GIS Drain Input Checklist

Re: Silas Davis Drain, Bower Farms Arm

Re: Silas Davis Drain: Bower Farms Arm

Map Correction-Field Verification

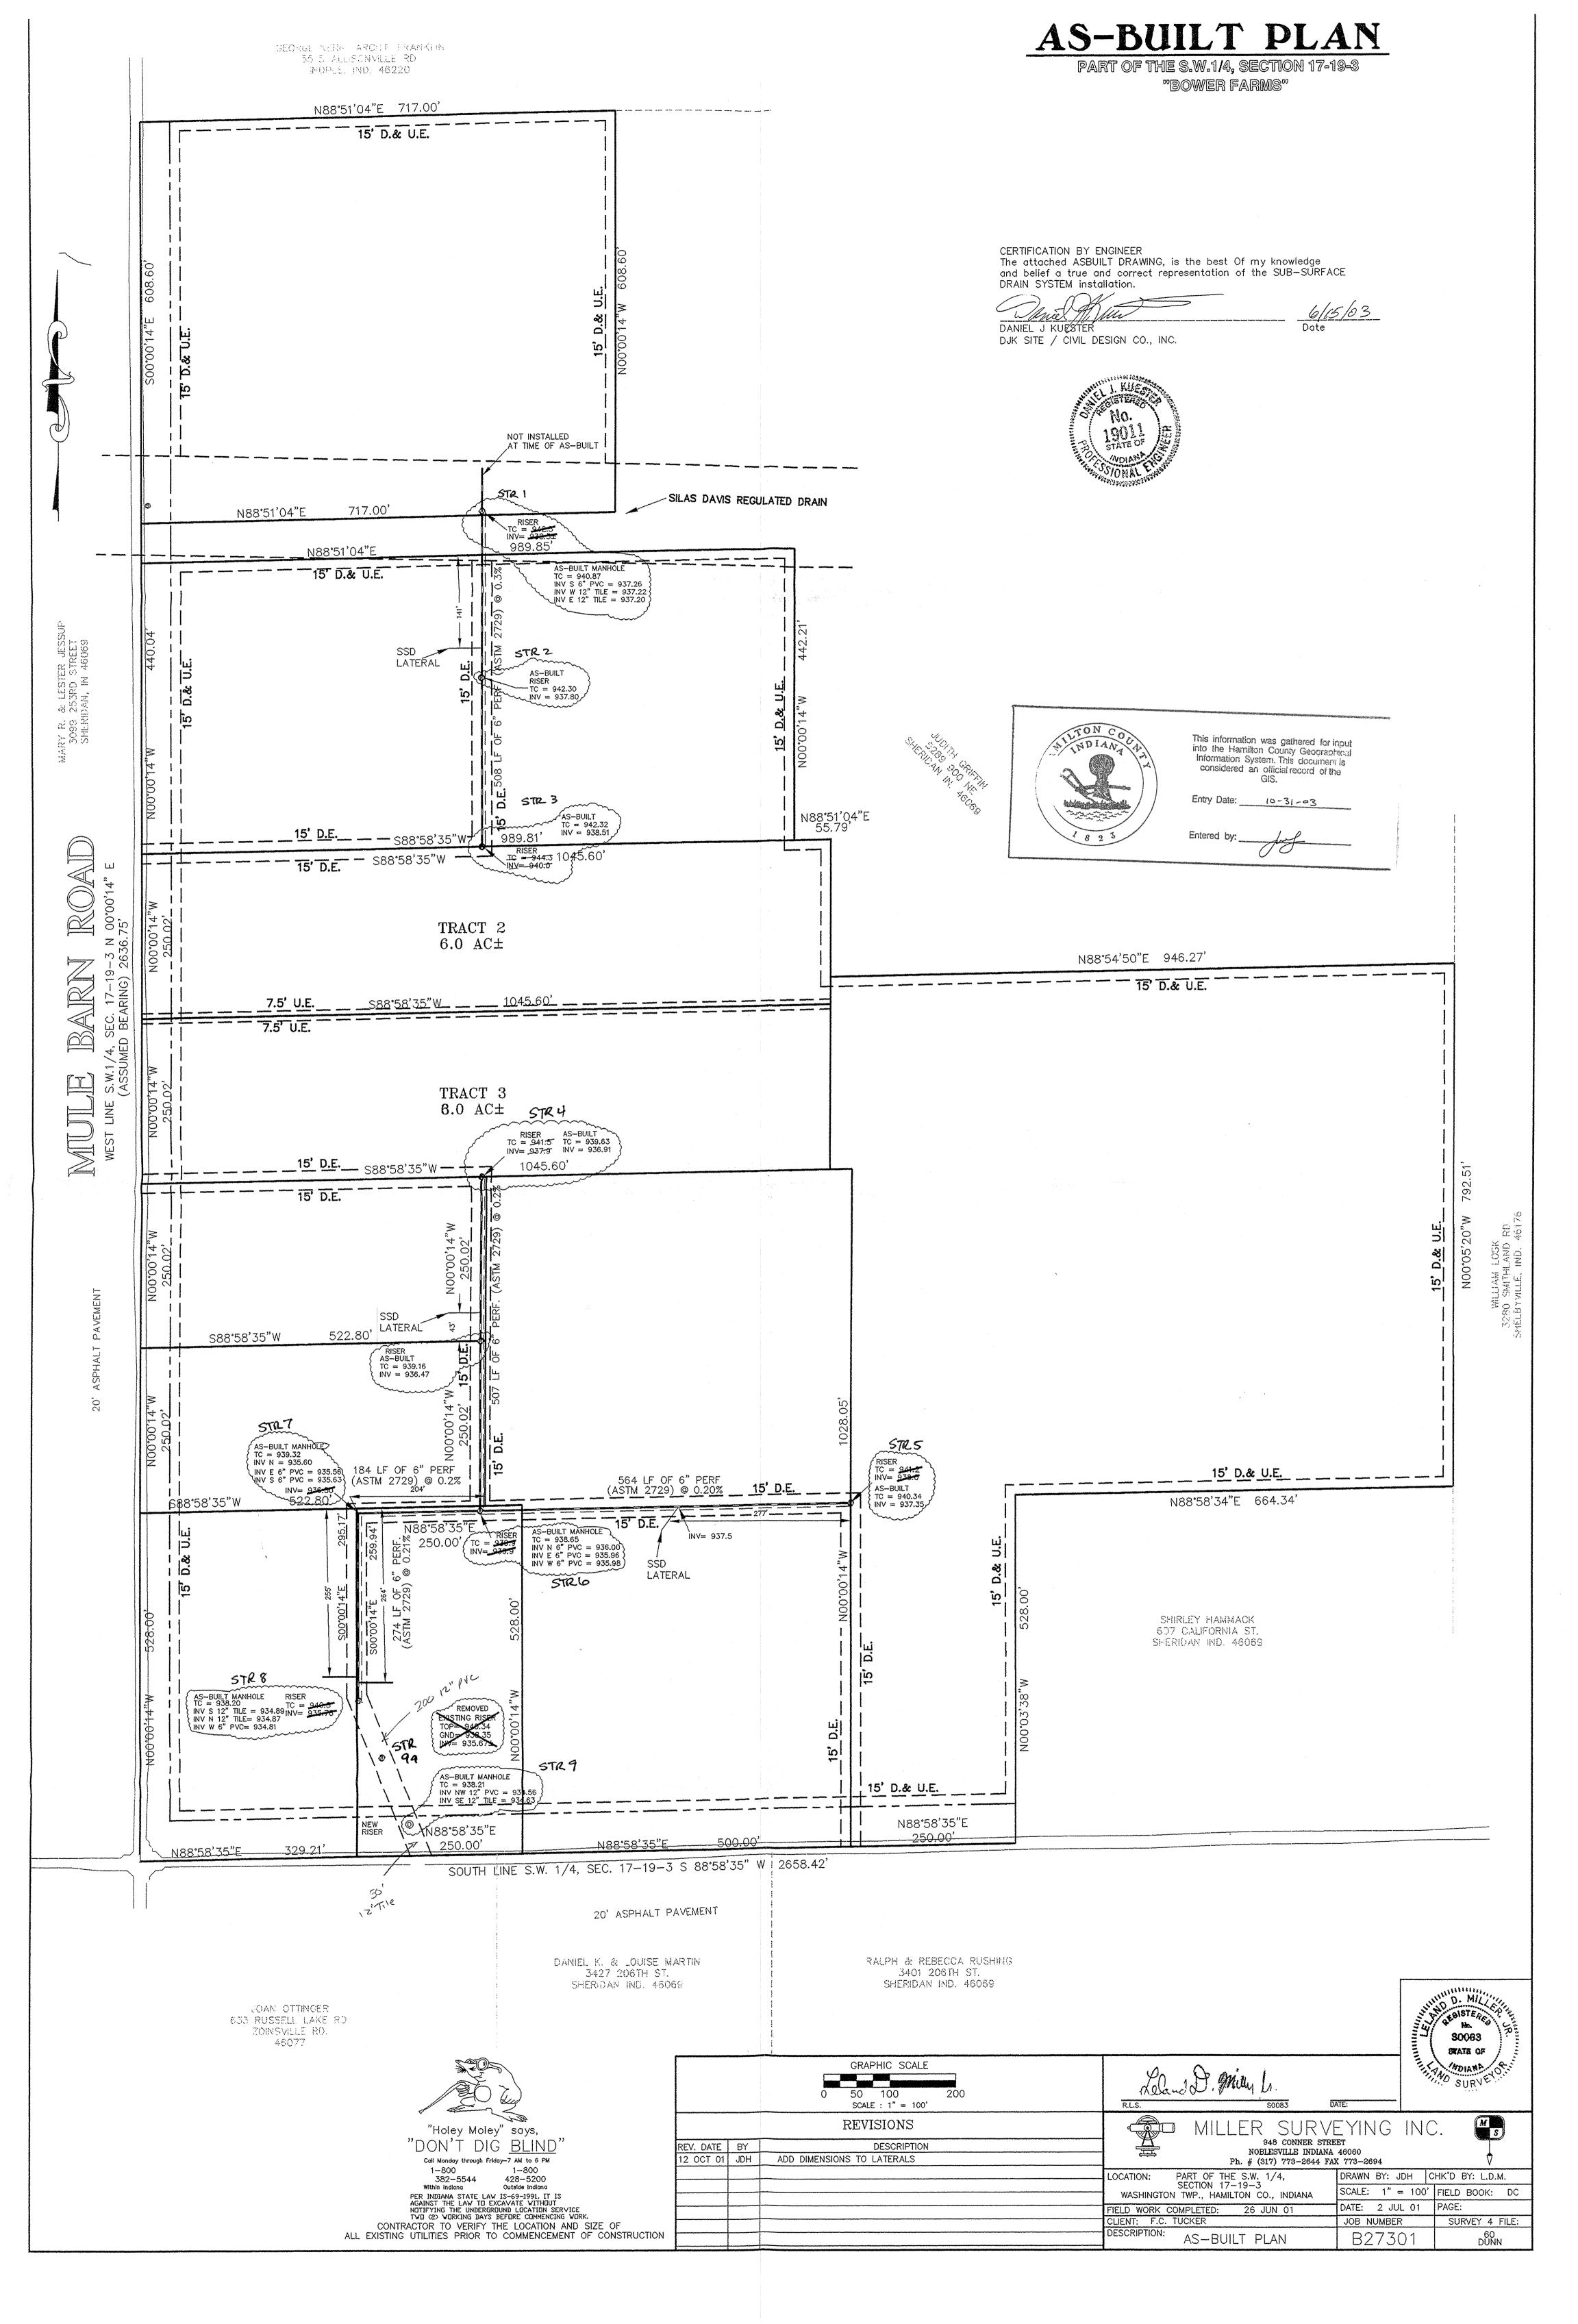
During construction, changes were made to the drain, which will alter the plans submitted with my report for this drain-dated August 13, 2001. The report was approved by the Board at the hearing held August 27, 2001. (See Drainage Board Minutes Book 6, Pages 122-123) The changes are as follows:

Structure:		T.C.:	I.E.:	Pipe:	Length:	Original Plans:	Difference:
	3	942.32	938.51				
	2	942.3	937.8	6	254		
	2	942.3	937.8				
	1	940.87	937.26	6	254

Note: 6"SSD stub from Structure 1 north into Tract 10 was not installed. This resulted in a reduction of 62 feet of drain. The length of the drain due to the changes described above is now 508 feet.
